FCO CA06199: Mean Well Power Supply PS4 for TH2

Document number: 719-00501A-B

- Trendsetter® NEWS 100
- Trendsetter NEWS 150

Figure 2: Mean Well PS4 with bracket and cables attached to Astec or Mean Well PS3

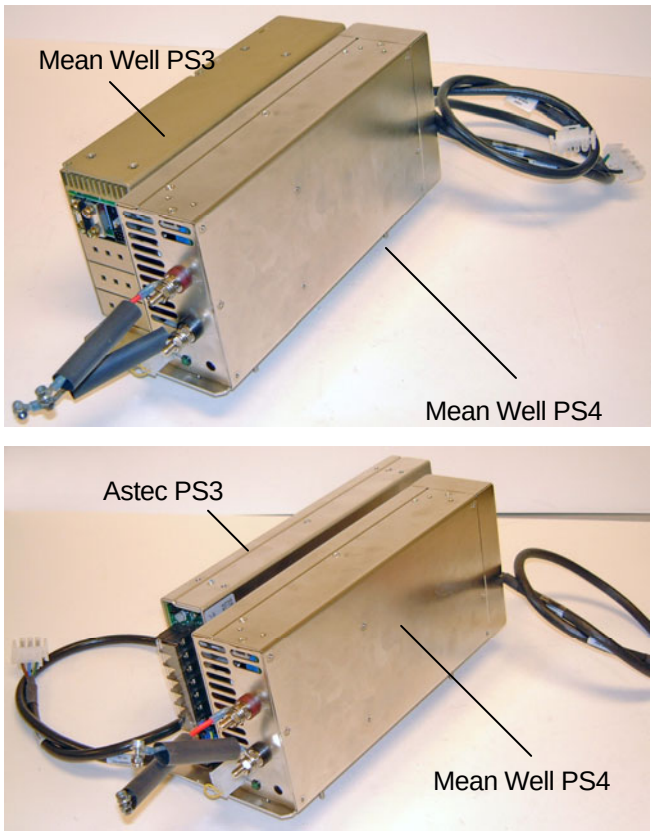
Because the new PS4 is larger than the power supply it is replacing, the combination of PS3 and PS4 will not fit into the previous power supply position. In order for both power supply units to fit, a new bracket has been attached to the PS4. You need to attach the existing PS3 to this bracket and then reattach the combination power supply unit back into the power box.

6. Disconnect thermal imaging head power cable 10-4850 from Astec or Mean Well power supply PS3.
7. Disconnect Astec or Mean Well power supply PS3 cable from PDB connector J3.
8. Disconnect the ground cable from Astec or Mean Well power supply PS3.
9. Remove Astec or Mean Well power supply PS3 from the power box.
10. Attach Astec or Mean Well power supply PS3 to the bracket holding the new Mean Well PS4 (see Figure 2).

Figure 3: Connecting 10-4850 to modified Mean Well PS4 connections

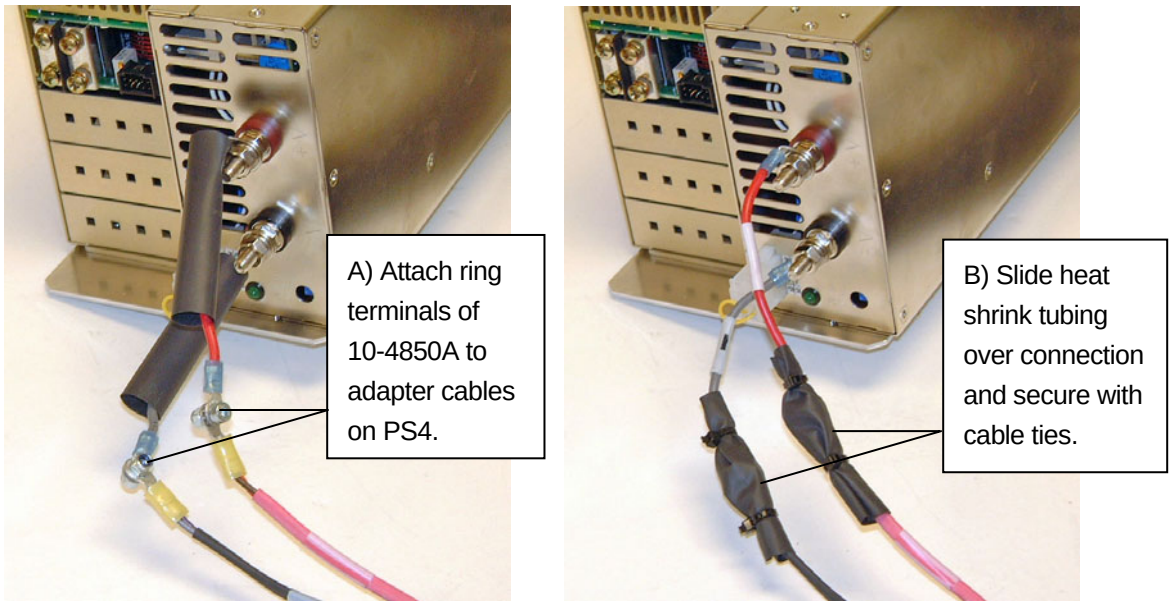
11. Attach the combination PS3/PS4 power supply unit with the new bracket to the power box.
12. Reconnect thermal imaging head power cable 10-4850A to PS3.
13. Connect thermal imaging head power cable 10-4850A to the short adapter cables on the new Mean Well power supply PS4, using a screw, nut, and star-washer (see A in Figure 3).
14. Cover the connections between cable 10-4850A and the short adapter cables on the Mean Well power supply PS4 with heat-shrink tubing. Use cable ties to secure the heat shrink tubing to each connection (see B in Figure 3).
